FINAL SITE GRADING CONSTRUCTION PLANS
FOR
VILLAGE AT LORSON RANCH FIL. NO. 1
FINAL GRADING / EROSION CONTROL PLANS

COVER SHEET
FINAL GRADING AND
EROSION CONTROL PLANS

V1_Grading & Erosion Control Plan.pdf Markup Summary

SHEET NUMBER
C0.1

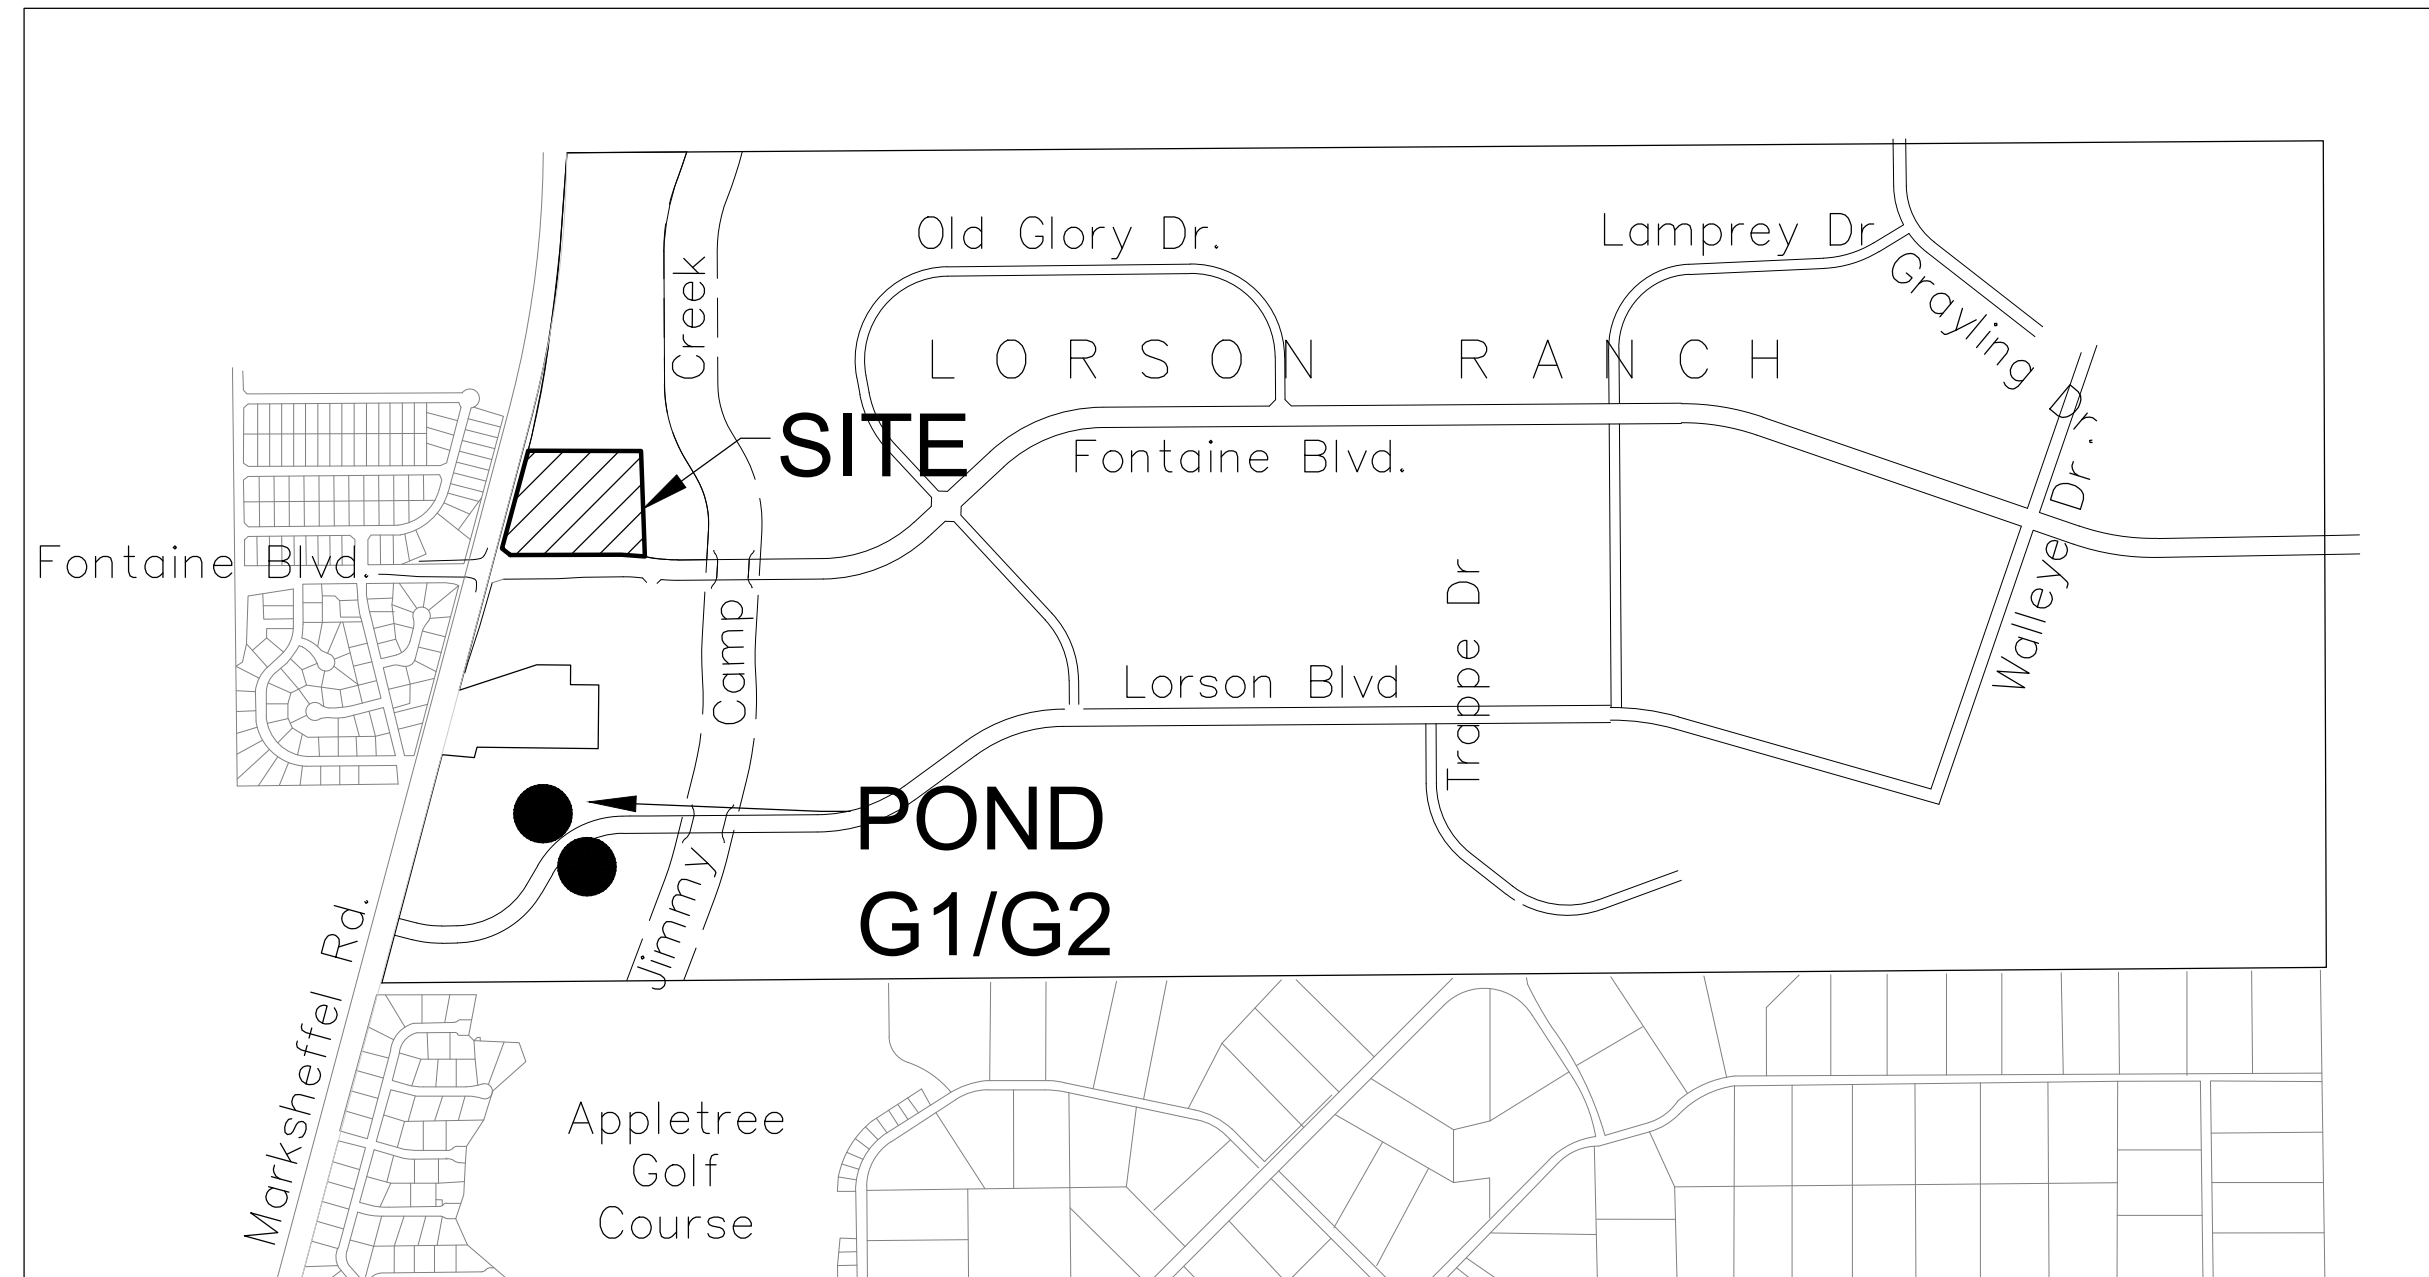
SF248
SF-24x

DATE: APRIL, 2024
 PROJECT NO. 100.070
 SHEET NUMBER C4.1
 TOTAL SHEETS: 7

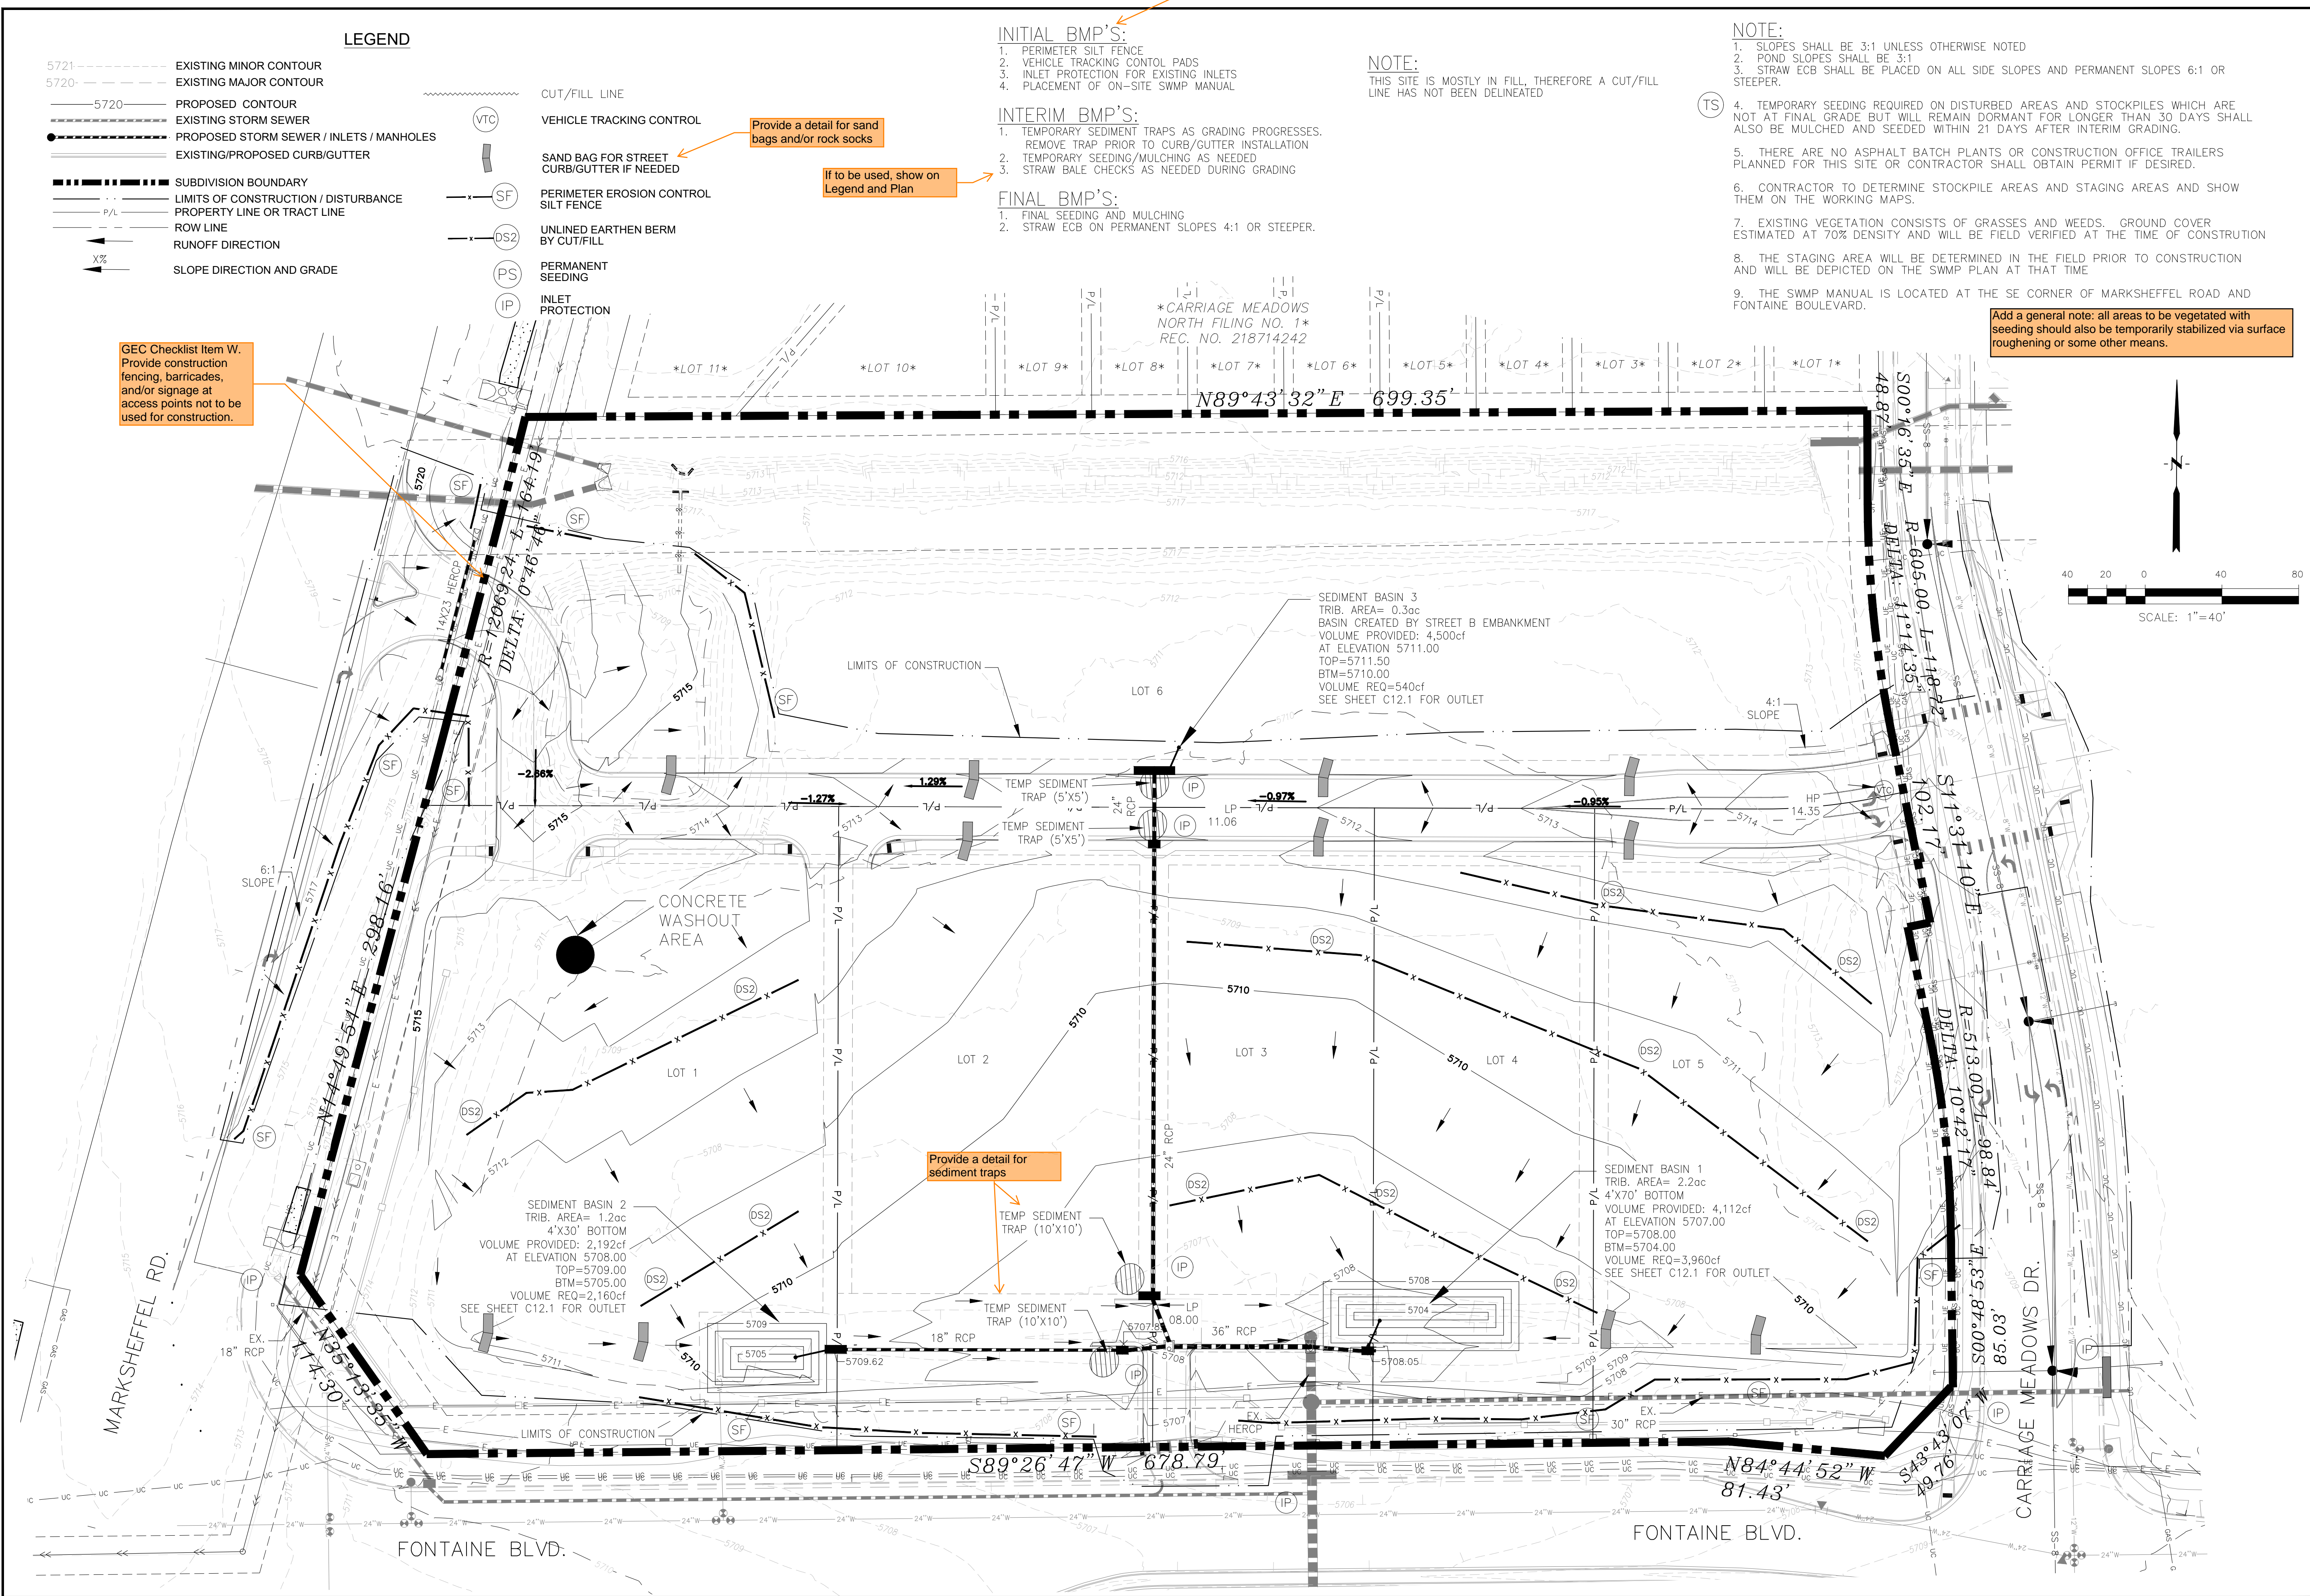
Add SB's to this phasing list.

Provide a detail for sand bags and/or rock socks

If to be used, show on Legend and Plan

Add a general note: all areas to be vegetated with seeding should also be temporarily stabilized via surface roughening or some other means.

GEC Checklist Item W. Provide construction fencing, barricades, and/or signage at access points not to be used for construction.

Provide a detail for sediment traps
